MANDATORY BULLETIN

MB No.: L410UVP-E/143a Revision 2

Subject: Modification of the electrical circuit of the propeller pitch lock system function test.

Revision 2 extends the applicability to S/N specified above, cancels inspection and adjustment of engine push/pull control rod and Beta Switch and adds the modification of the electrical circuit of the propeller pitch lock system function test.

Fig. 1

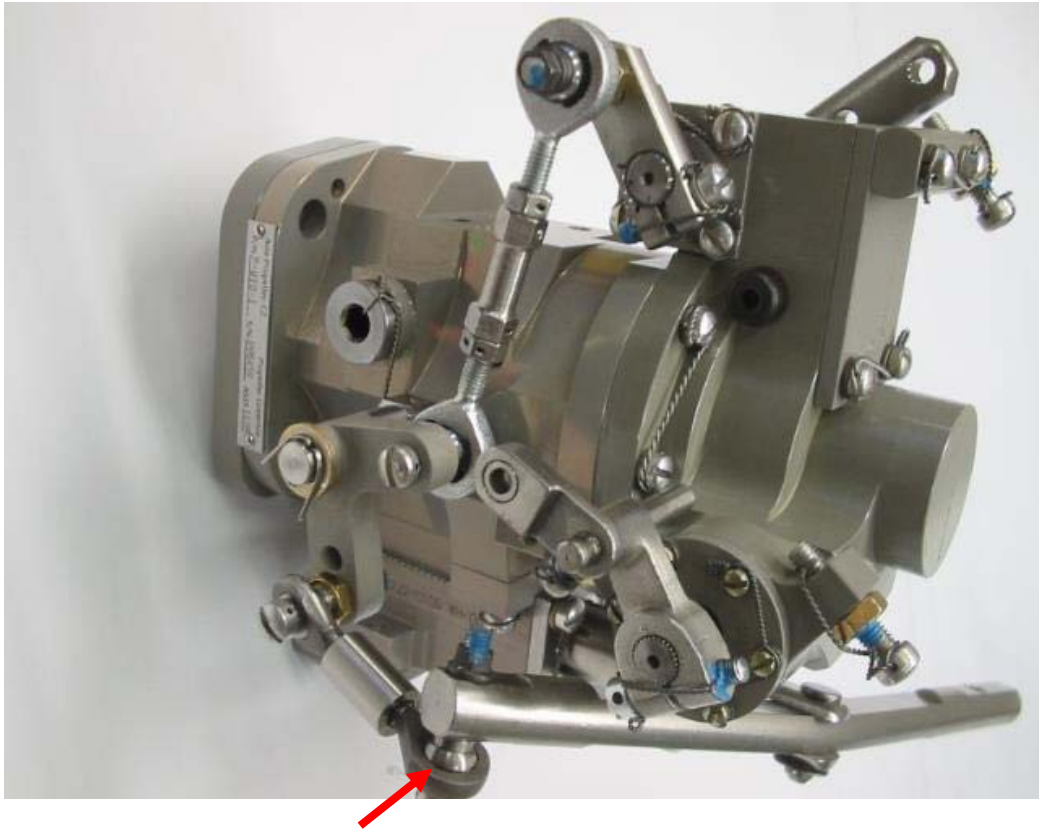
- Disconnect the BETA feedback lever from the connecting rod - see Fig. 1.

- Move the LH / RH TCL in the cockpit to the BETA area and check that the +28 V DC voltage on the M893 flange connector of the LH / RH engine has disappeared (voltage range from 0 to 1.5 V) and at the same time the PROPELLER PITCH LOCK cell (on the instrument panel glareshield - LH / RH) has gone off.
- Release the PROPELLER PITCH LOCK TEST button and switch off the ELU LH / RH, CWD LH ENGINE, AIRFRAME, ELECTRO, RH ENGINE circuit breakers and BATTERY I, II switches on the overhead panel.
- Connect back the M893 connector of propeller pitch lock on the LH / RH engine.
- Connect the BETA feedback lever to the connecting rod - see Fig. 1.

Fig. 2

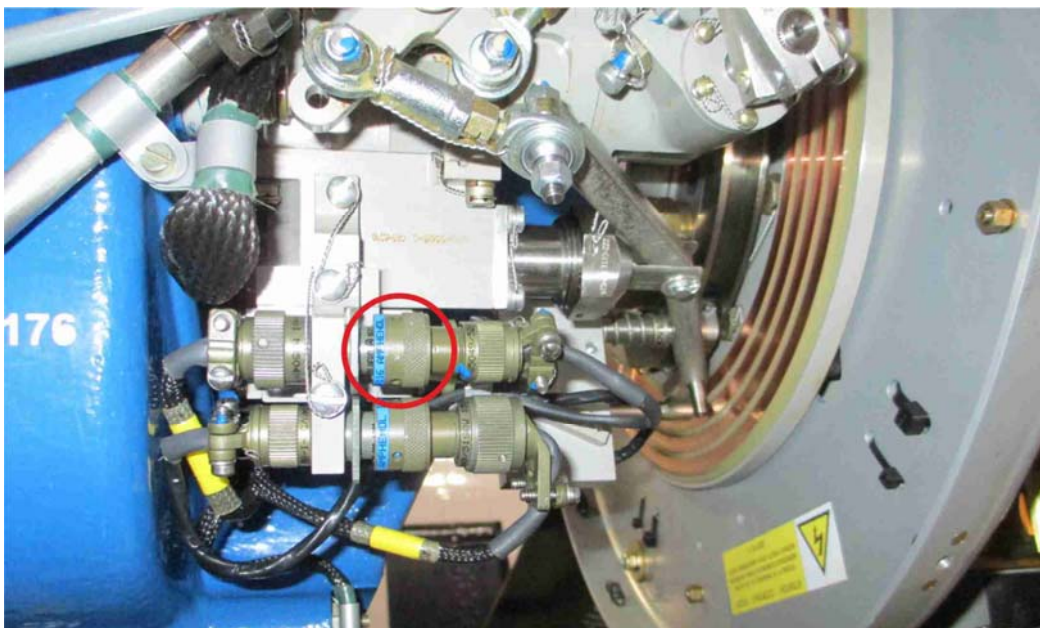
- Disconnect the M893 connector of the propeller pitch lock (component of the P-W22-1 propeller governor) on the LH / RH engine - see Fig. 2.

Fig. 3

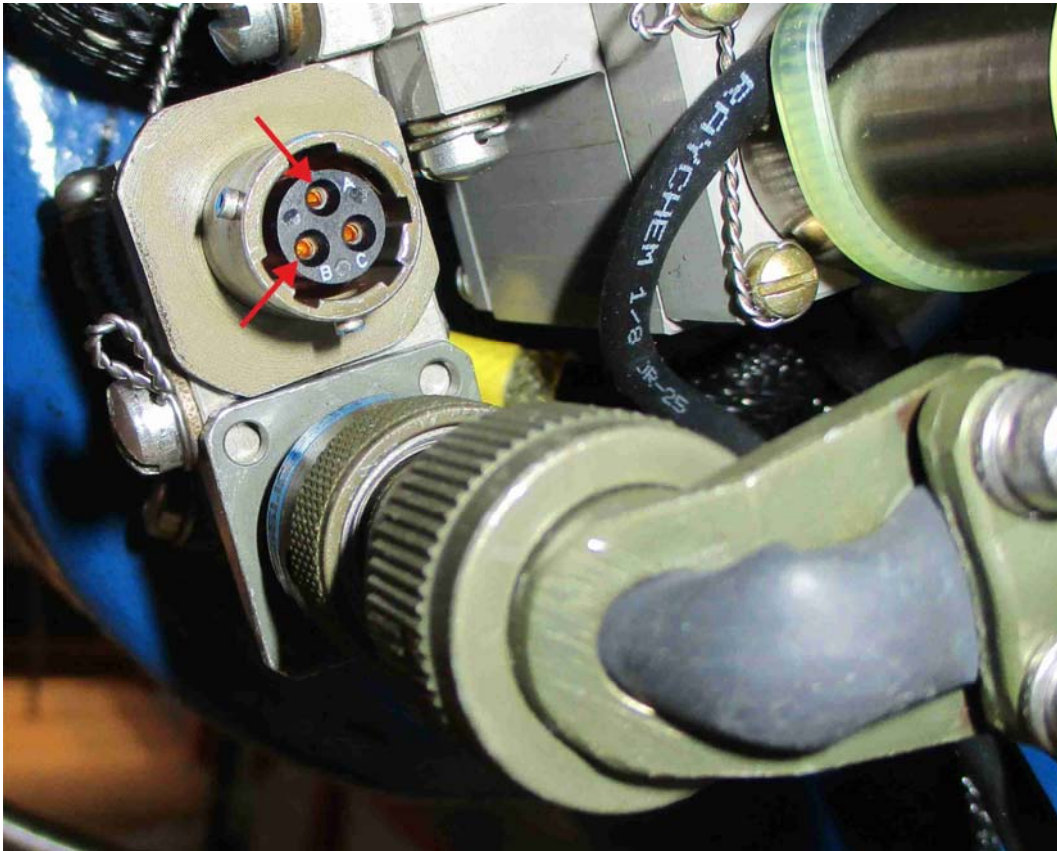
- Connect the voltmeter to the „A“ and „B“ pins on the M893 flange connector on the LH / RH engine. Connect the red wire of voltmeter (+ voltage pole) on the „A“ pin and the black wire of voltmeter (- voltage pole, ground) to the „B“ pin. Set the appropriate range of voltage to min. 30 V DC on the voltmeter.
